Technical Note 01A

Project: Planning Application DC/23/2279: Land North of the Rosary, Partridge Green

Subject: Review of Additional Footway Provision Technical Note (Motion, 03 Oct 2024)

Prepared by: Bruce Bamber **Date:** 22 November 2024

Figure 1: Forward Visibility to Pedestrian Crossing (northbound)

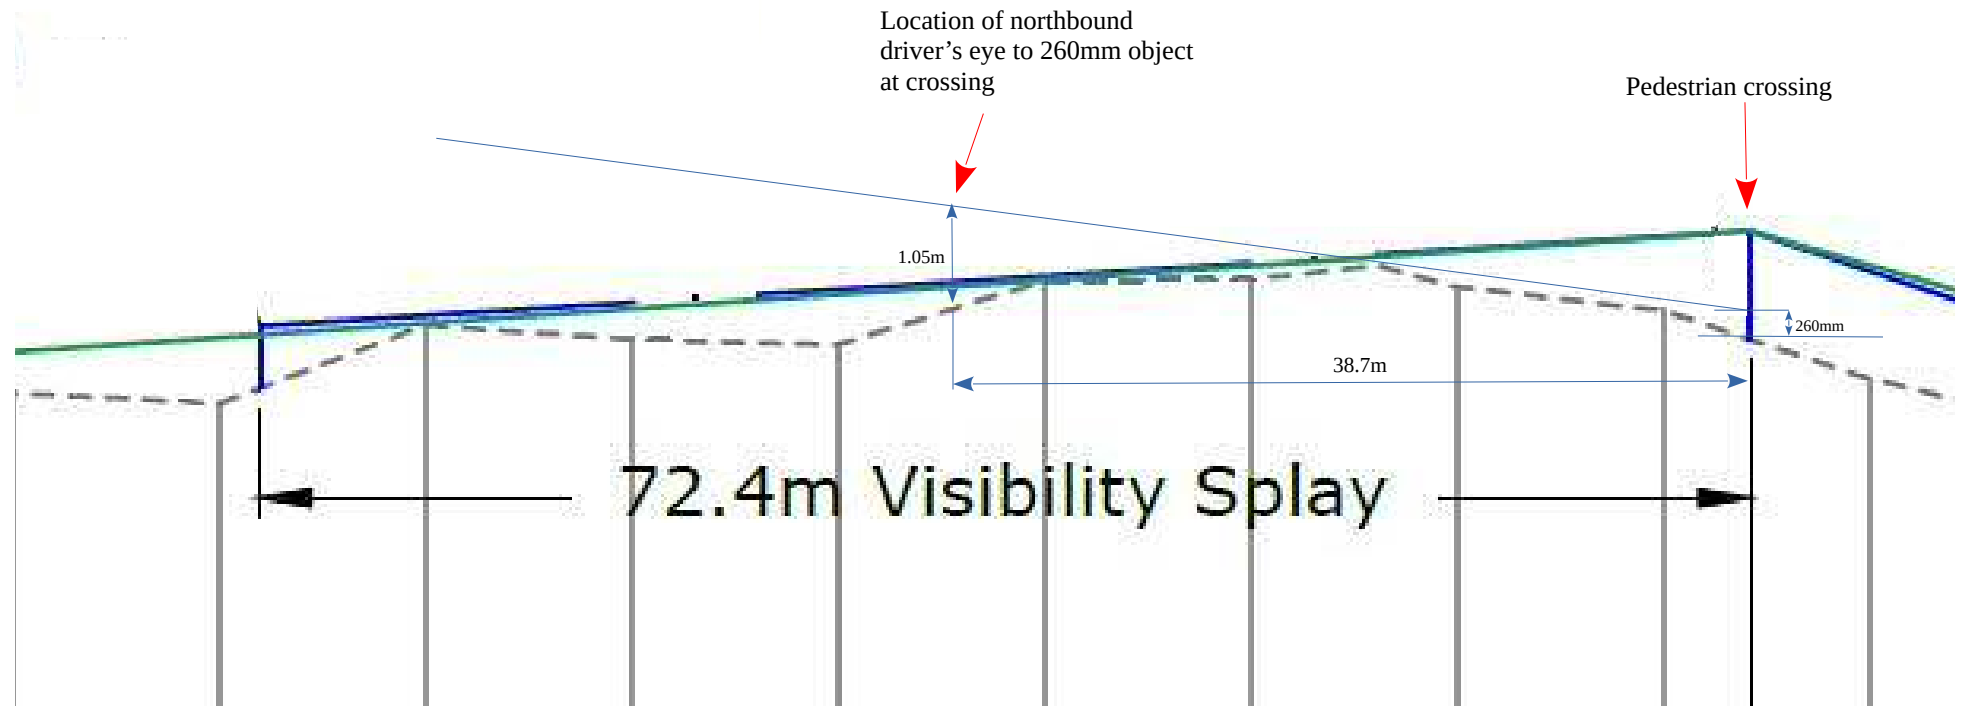
18. **Figure 1** attached is based on the long section of Church Road included in the plan attached to the Technical Note. The correct driver's eye level and object height on the pedestrian crossing have been added.

19. With the correct heights the forward visibility to an object 0.26m in height is shown to be 38.7m. This distance falls far short of the 72.4m identified in the Technical Note. It also falls far short of the correct visibility splays that are discussed in the following section. The conclusion is that the Technical Note is flawed and provides incorrect information that could lead to a highly dangerous arrangement, if approved.

32. The use of incorrect driver's eye and pedestrian heights obscures the fact that a northbound driver would have a forward visibility of only 38.7m to a person lying in the carriageway at the crossing. This is **less than half** the absolute minimum forward visibility required for drivers travelling at the observed speeds along Church Road (88.9m).

Appendix 1: Plan Showing Proposed New Footway

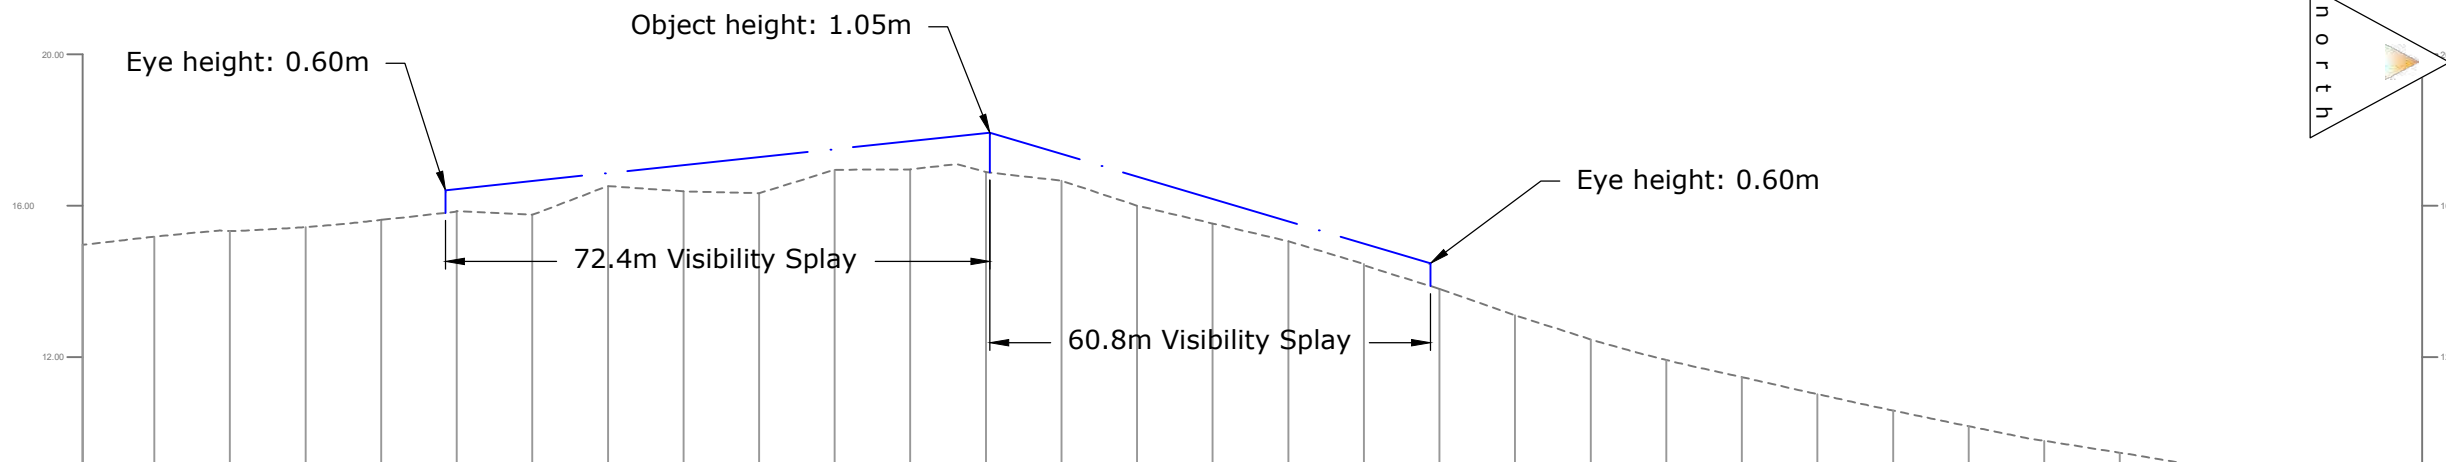
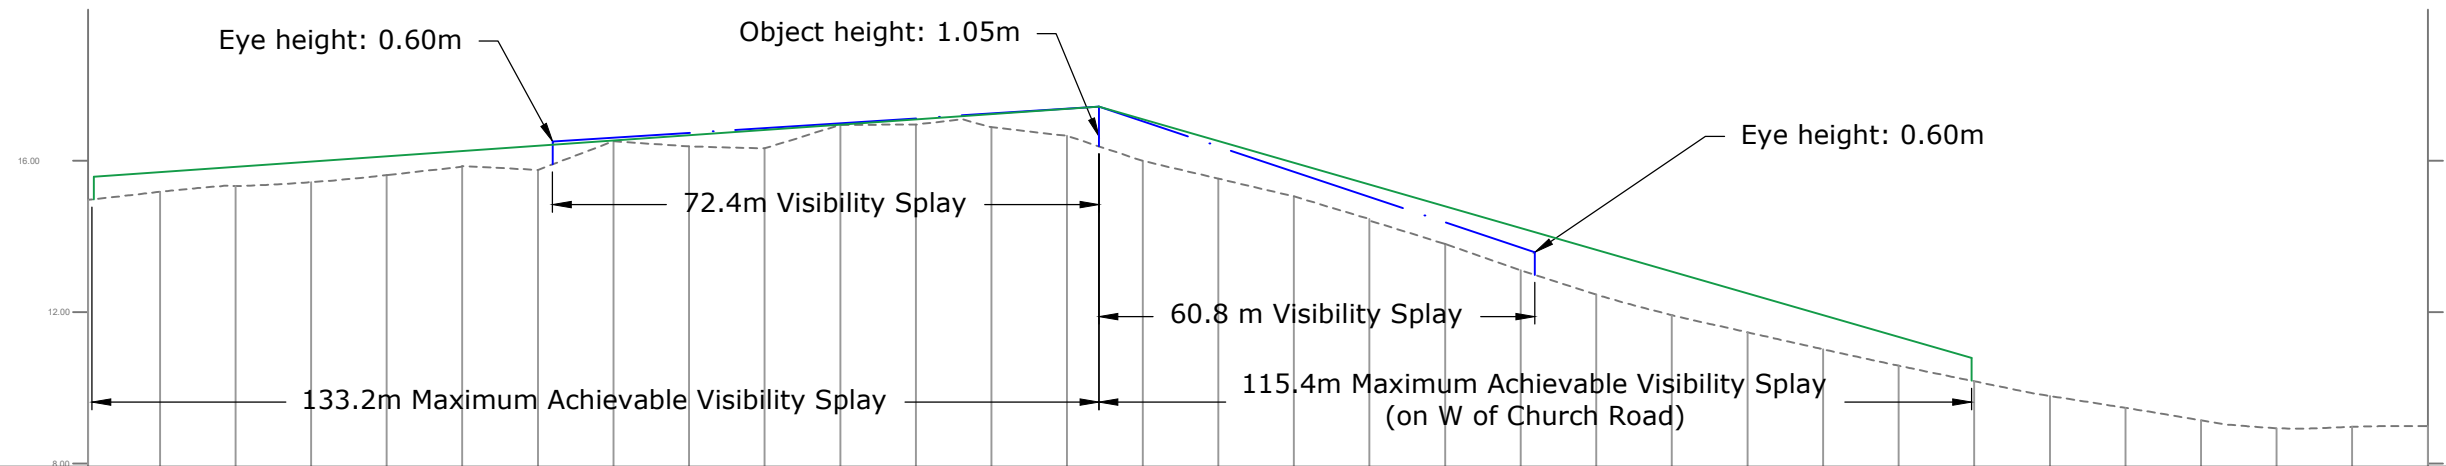
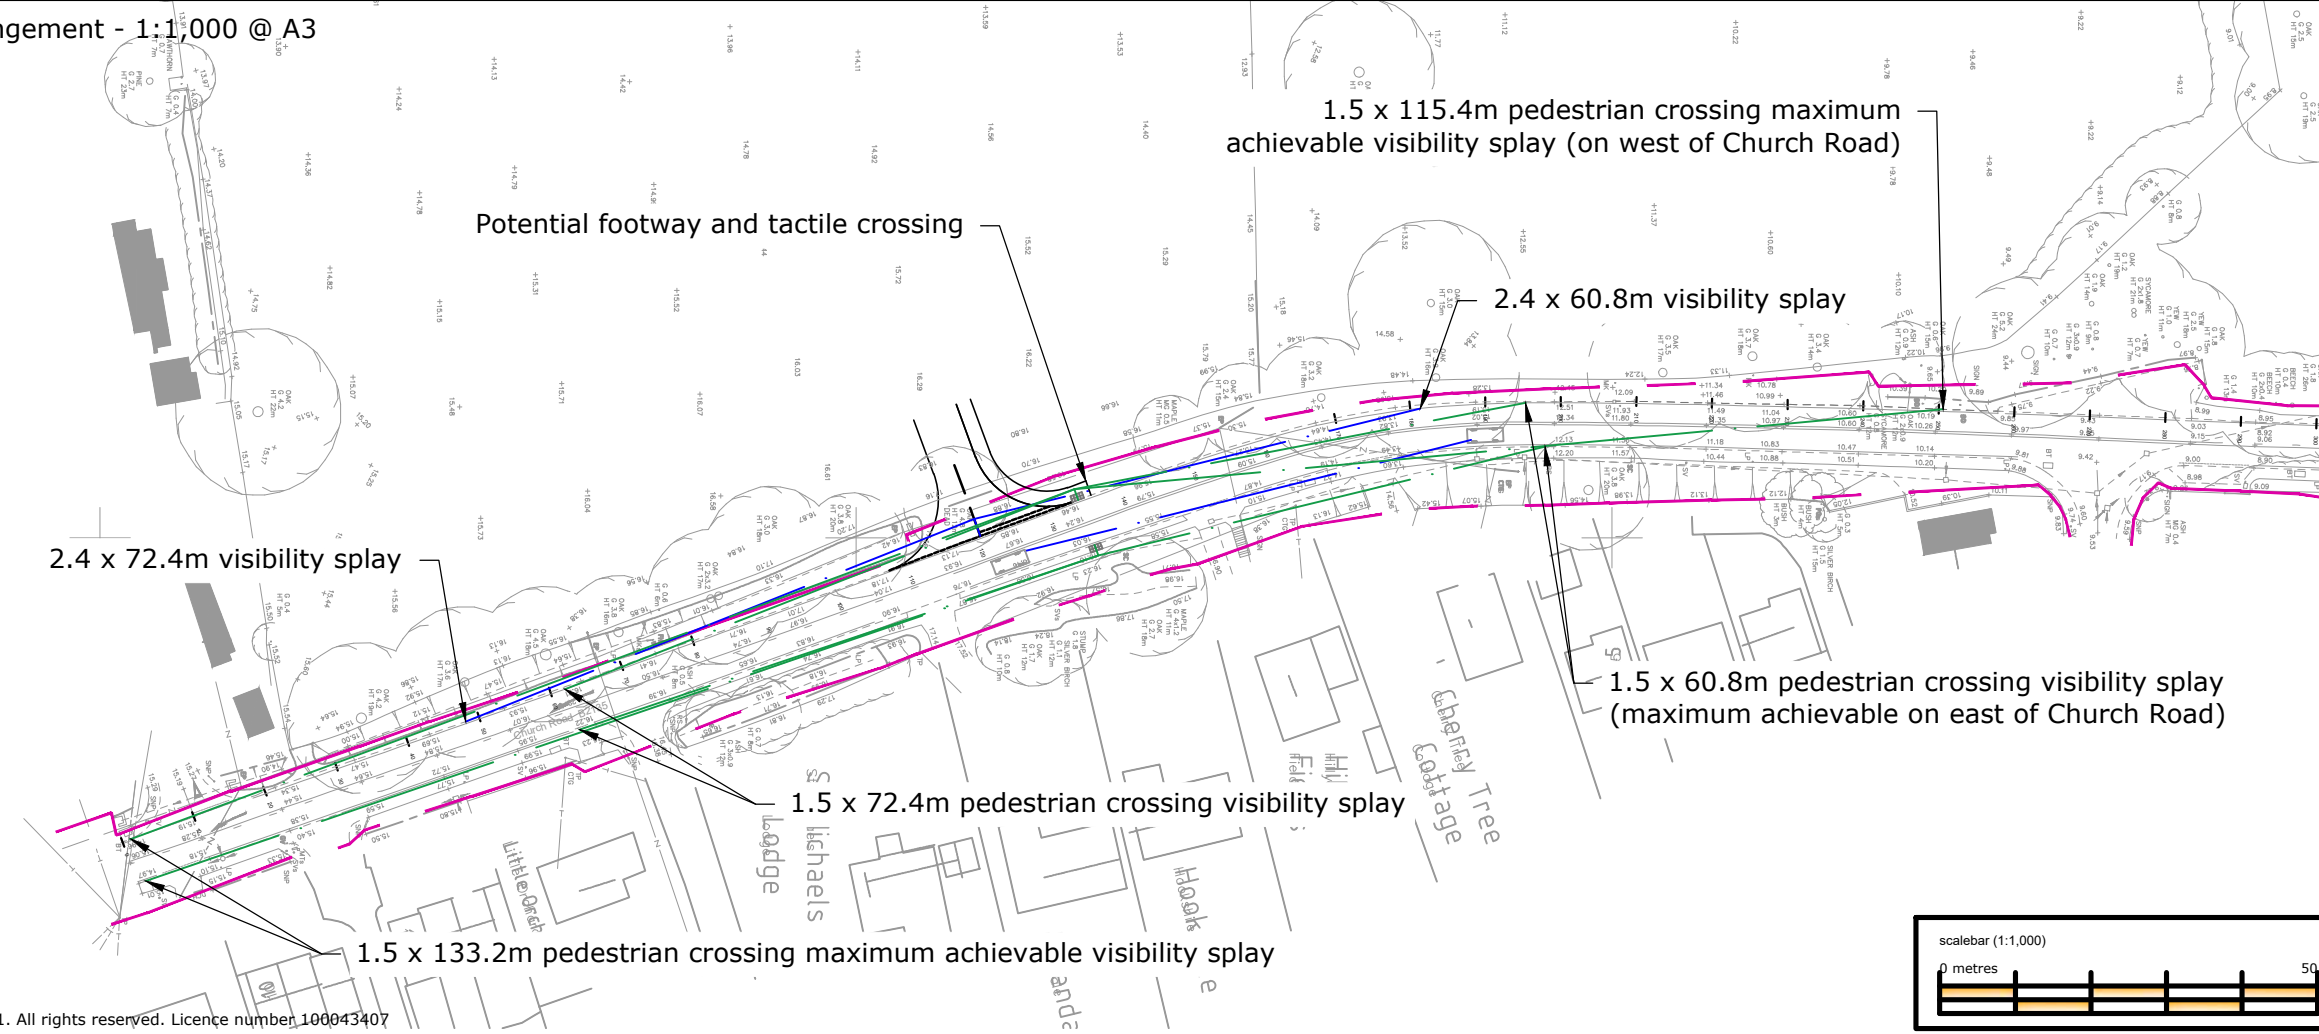
'At this extent [60.8m from crossing], the visibility splay is located at the same distance onto the verge as existing telegraph poles and lighting columns, demonstrating that the vegetation and levels further onto the verge would not obstruct the splay in this direction' (Technical Note, para. 2.4)

16. Although the meaning of this statement is obscure, the fact is that a visibility splay of 60.8m is insufficient to allow a southbound driver to see a person lying within the carriageway or even a small child close to the crossing and any visibility splay in excess of 60.8m would be obstructed to such an extent that an adult would not be visible without reconfiguration of the highway verge.

17. The plan attached to the Technical Note is incorrect. It suggests that a driver's eye level is at 0.6m above the carriageway and that the height of an object on the pedestrian crossing is 1.05m. As has been shown above with reference to technical standards, these figures are incorrect. A driver's eye should be taken as 1.05m above the carriageway surface and the object height at the crossing should be taken as between 0.26m and 2.0m³. This error has serious implications for visibility for drivers approaching from the south.
